**CITY OF ST. PETERSBURG
PLANNING & DEVELOPMENT SERVICES DEPT.
DEVELOPMENT REVIEW SERVICES DIVISION**

**DEVELOPMENT REVIEW COMMISSION
STAFF REPORT**

**SITE PLAN REVIEW
PUBLIC HEARING**

CASE NO.:	23-31000002	PLAT SHEET:	E-4
REQUEST:	Approval of a site plan to construct a 14-story building with 192-hotel rooms and a 127-space parking garage. The applicant is requesting floor area ratio bonuses and a variance to the minimum sidewalk width to protect an existing grand tree.		
OWNER:	KT ST Pete Runner, LLC 105 NE 1 st Street Delray Beach, FL 33444		
AGENT:	R. Donald Mastry Trenam Law 200 Central Avenue, Suite 1600 St. Petersburg, FL 33701		
ADDRESSES:	232 & 256 2 nd Street N.		
PARCEL ID NUMBERS:	19-31-17-74466-016-0010 and 0011		
LEGAL DESCRIPTION:	On File		
ZONING:	Downtown Center (DC-1)

Landscape Plan
Scale: N.T.S

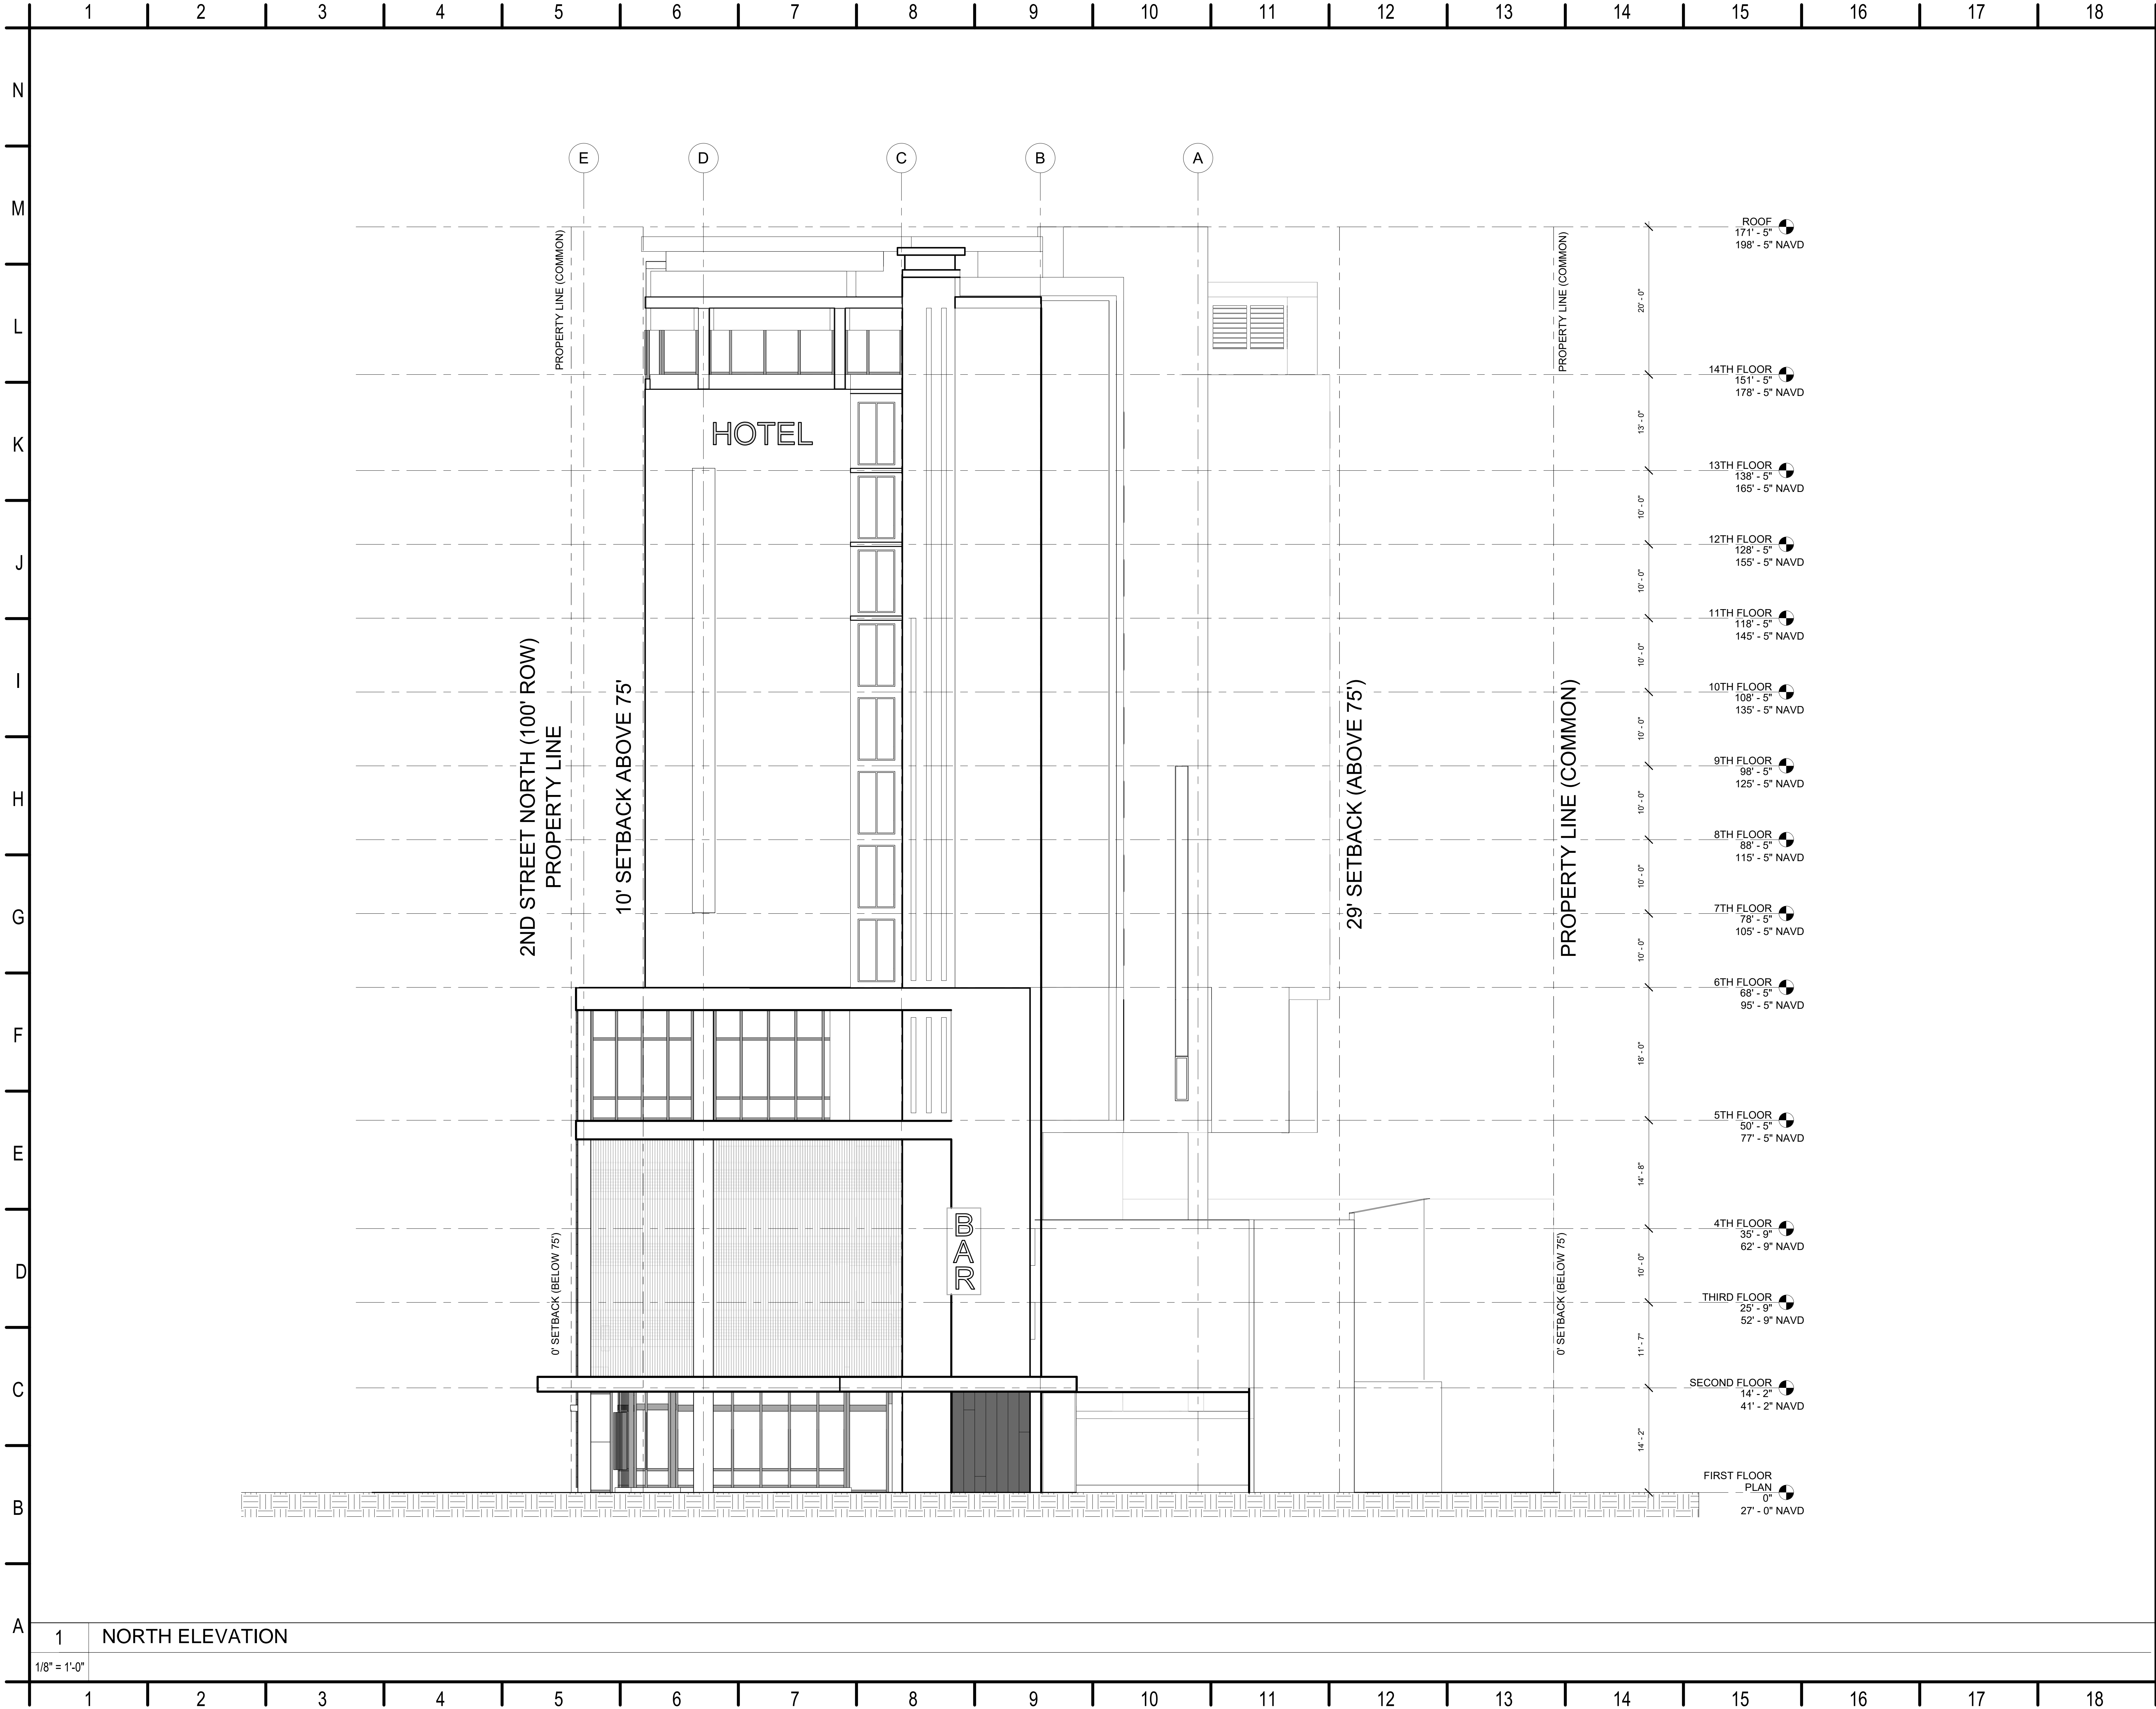
- a. The site plan shows reducing the required 10-foot sidewalk to 5-foot near the northeast property corner due to an existing 53" tree. However, the site plan also shows adjacent "open space" to the south of the 5-foot wide sidewalk within the site boundary, and the survey of existing conditions shows that there is additional space between the existing sidewalk edge adjacent to the tree and the property line to accommodate a wider sidewalk. ECID recommends that **Public Sidewalk Easement** be dedicated within this "open space" and that the public sidewalk be expanded into this open space as necessary to provide the sidewalk width required by City Code.

Figure 21. Shared property line at the rear.

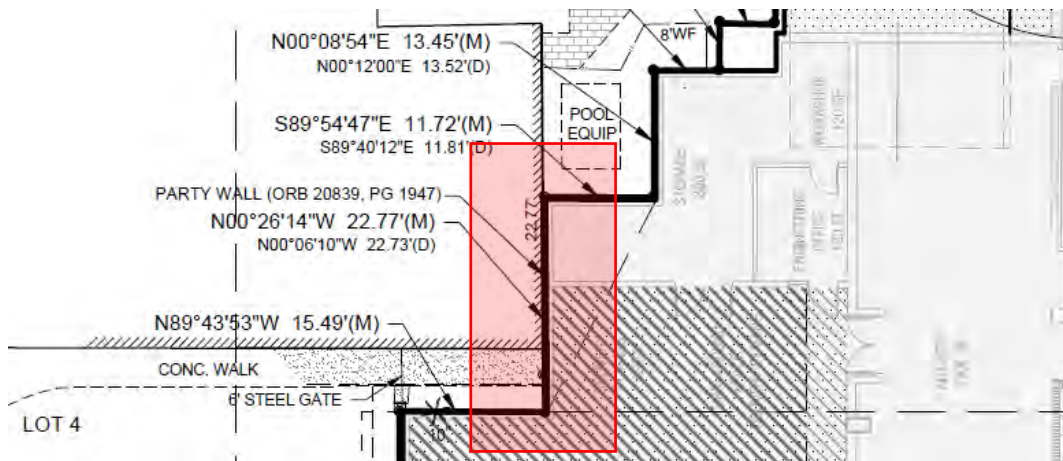
Context Study. Site plan review applications within the Downtown St. Petersburg National Register Historic District typically include elevations showing the setback and height relationship to adjacent buildings; however, the technical and rendered elevations submitted with this application do not include the neighboring building to the west. UPHP staff is unable to provide any detailed analysis except to generally state that the tower element is positioned away from the shared property line.

The application narrative states that, “The proposed setbacks and separation distinguish the Project from surrounding historic resources and allow for ample visibility to them. No character defining elements of any historic resource will be obstructed by the Project.” The existing swimming pool and patio on the neighboring property creates some separation as noted by the applicant, but the applicant has not addressed how the conjoined buildings will be coordinated at the location illustrated in Figure 20 above and Figure 21 below. The historic building includes several windows that may be blocked, and an eave that may be clipped, by the proposed parking structure. How will the property ownership, architectural design, building code, fire and life safety standards influence the final design and be resolved?
